**ADDENDUM
NO. 1**

October 28, 2022

**LIBERTY ELEMENTARY SCHOOL RENOVATIONS
Chesterton, IN 46304**

This Addendum consists of Pages ADD 1-1 and attached Addendum No. 1 from Gibraltar Design dated October 26, 2022 and consisting of 4 pages, Hardware Set 17, and 23 Drawings.

© GIBRALTAR DESIGN SHEET
A-601

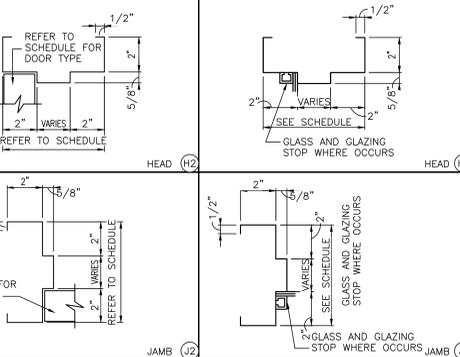
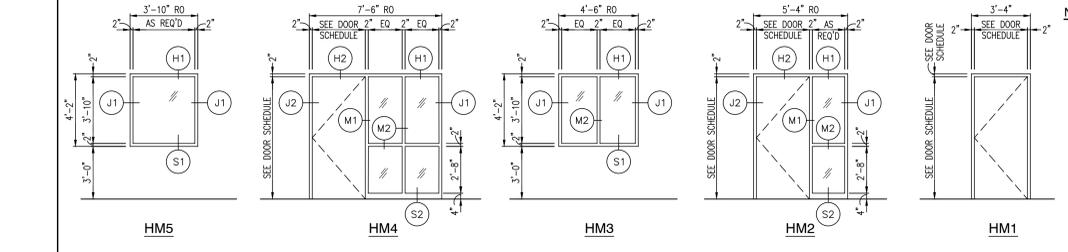
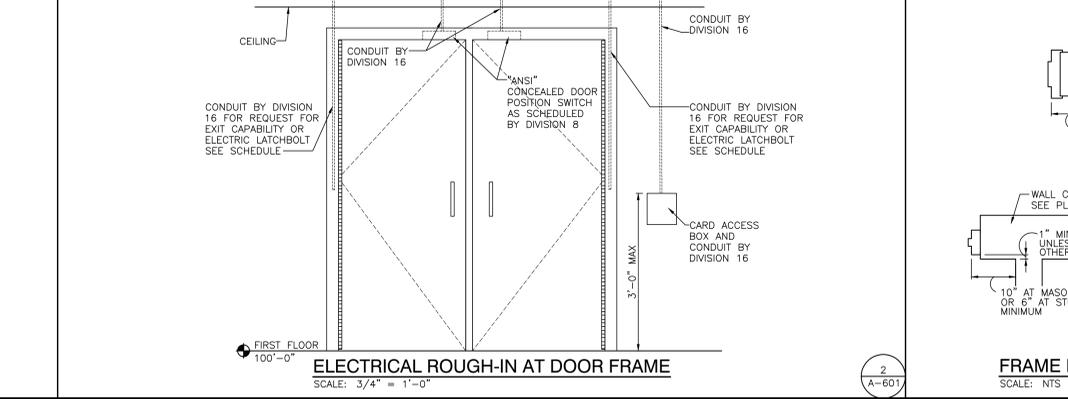
6. Sheet A-601

- A. Refer to revised full size drawings, included in this Addendum, for the following revisions:
1. Add door A-127A.

GIBRALTAR DESIGN SHEET
B PD102

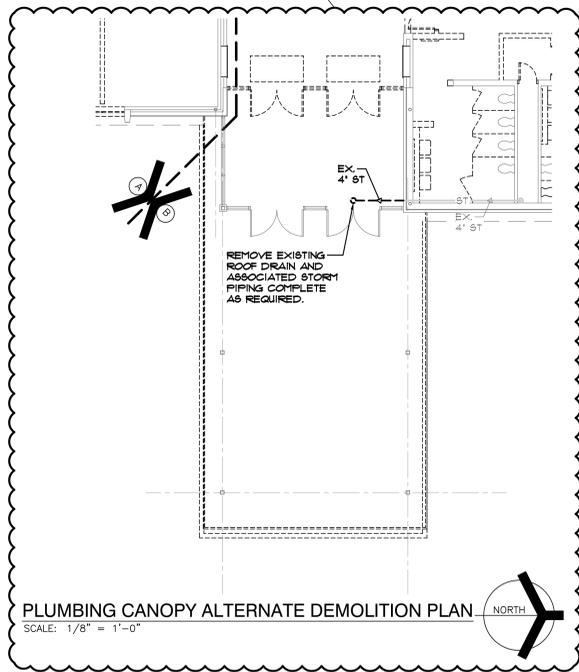
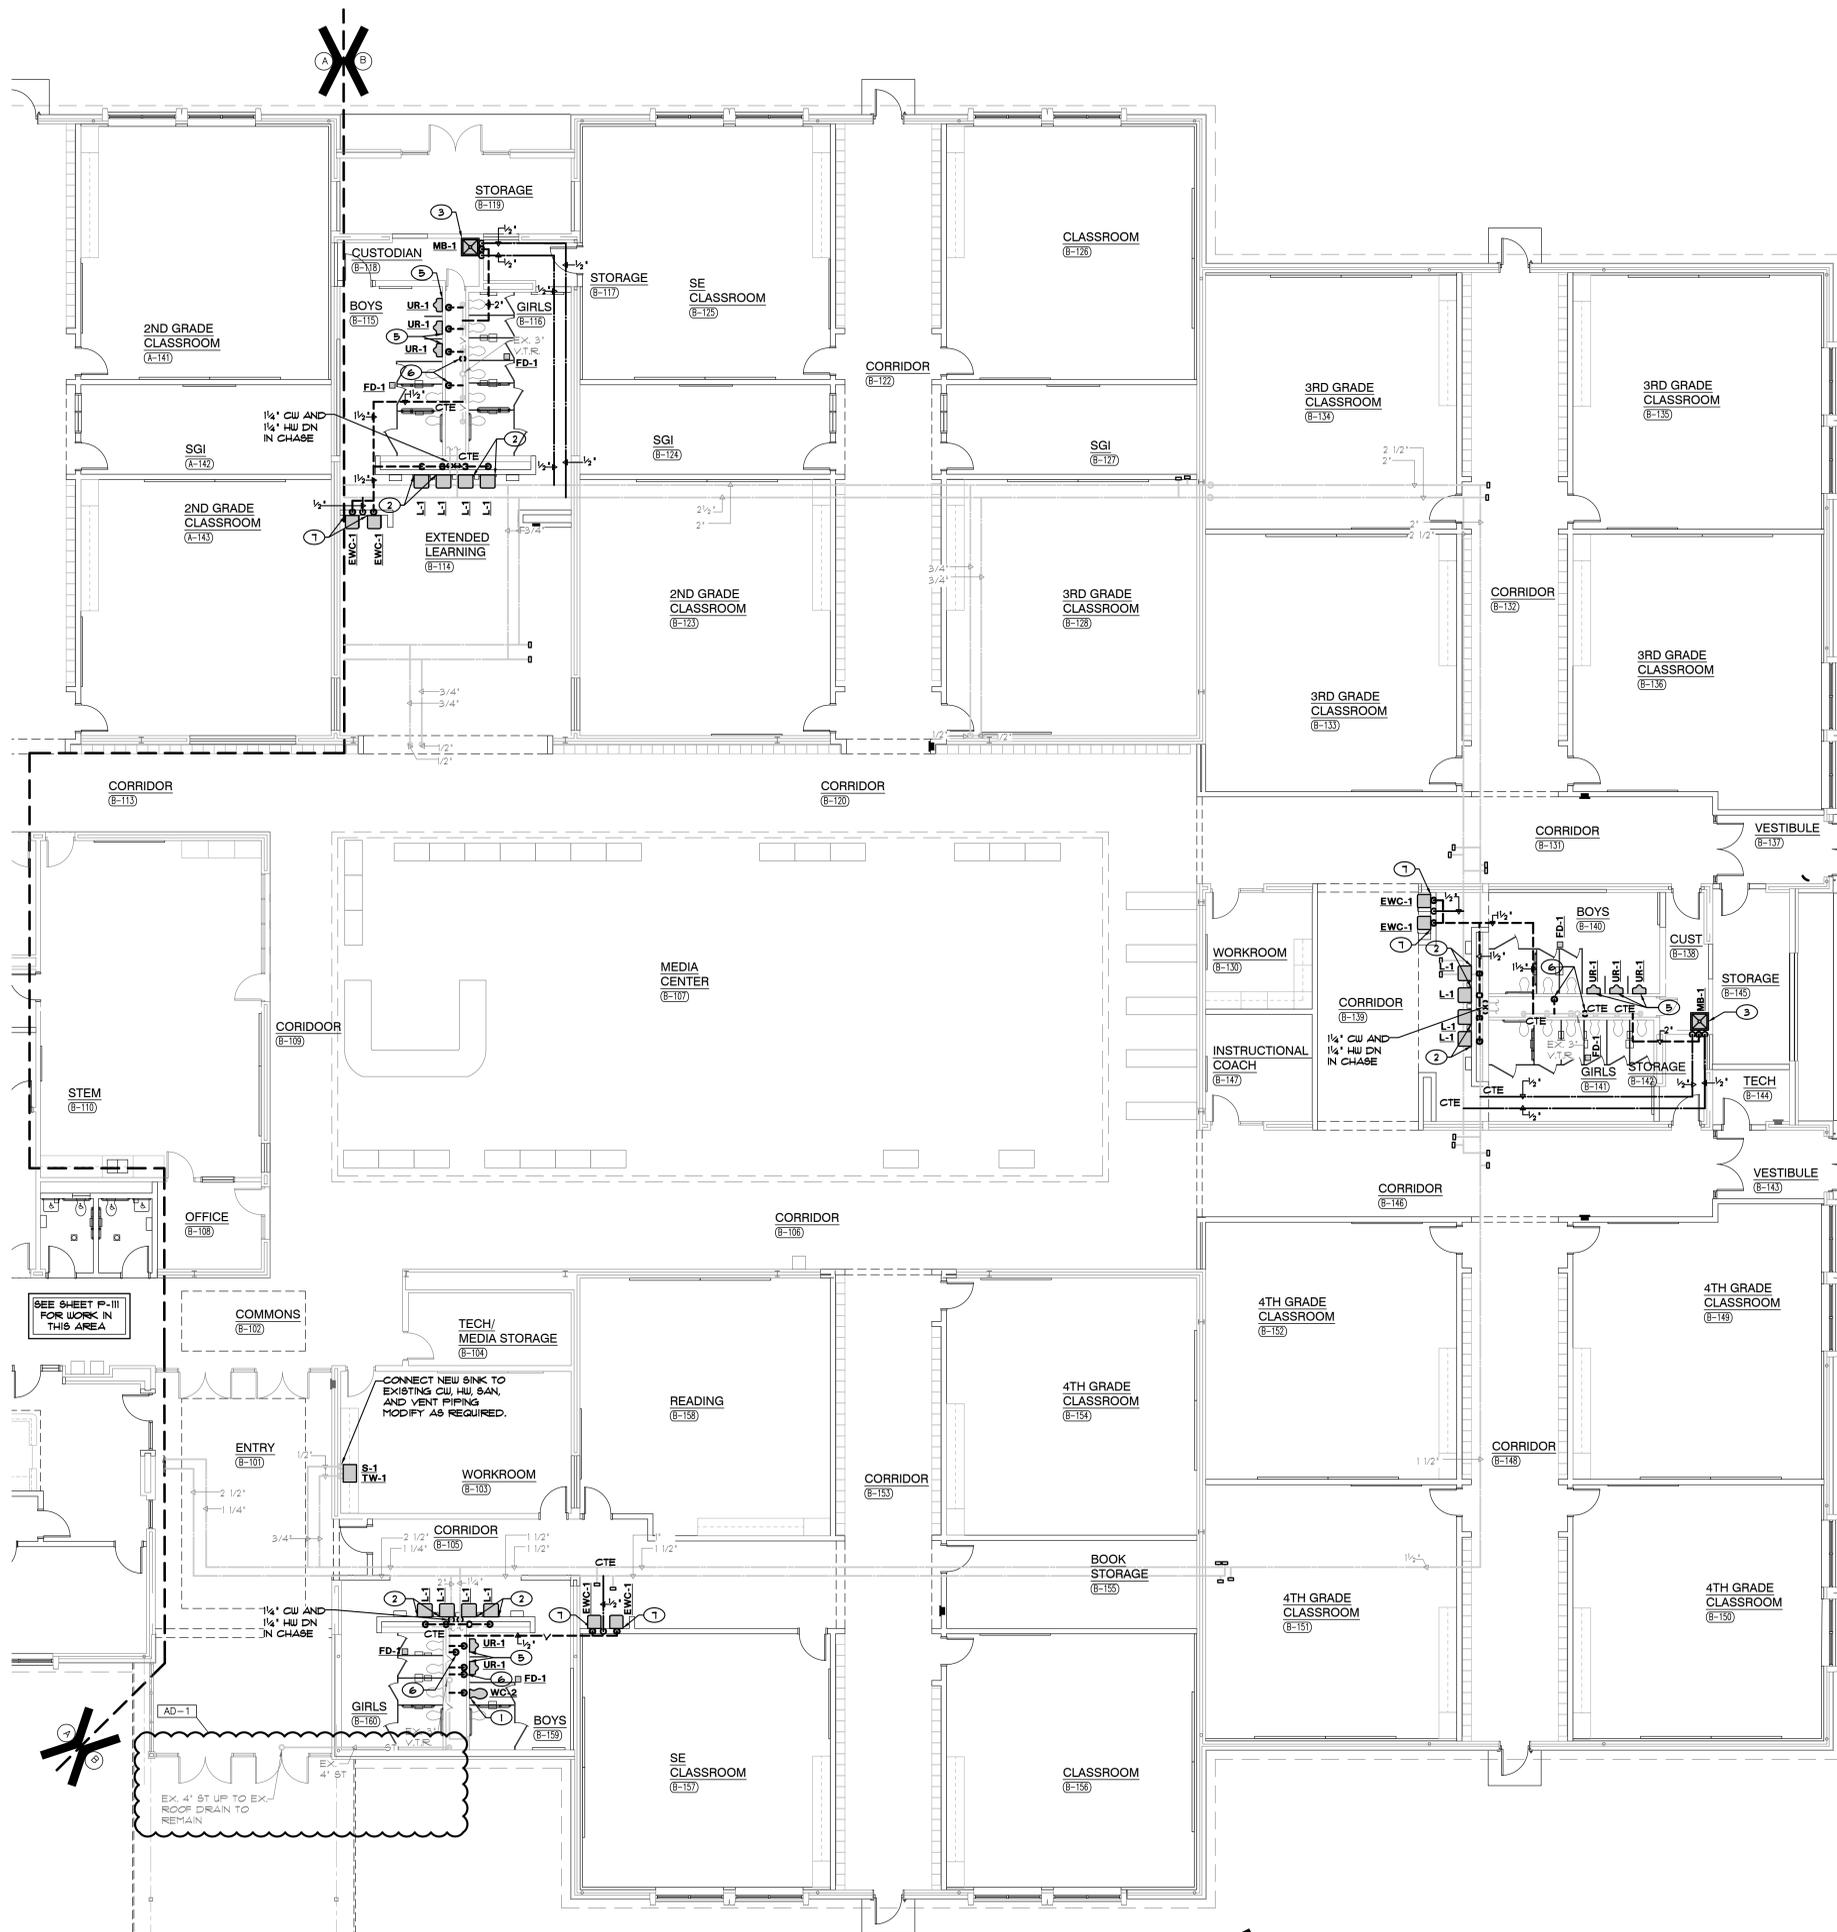
14. Sheet PD102 and P-112

- A. Refer to two revised full size drawings, included in this Addendum, for canopy alternate.
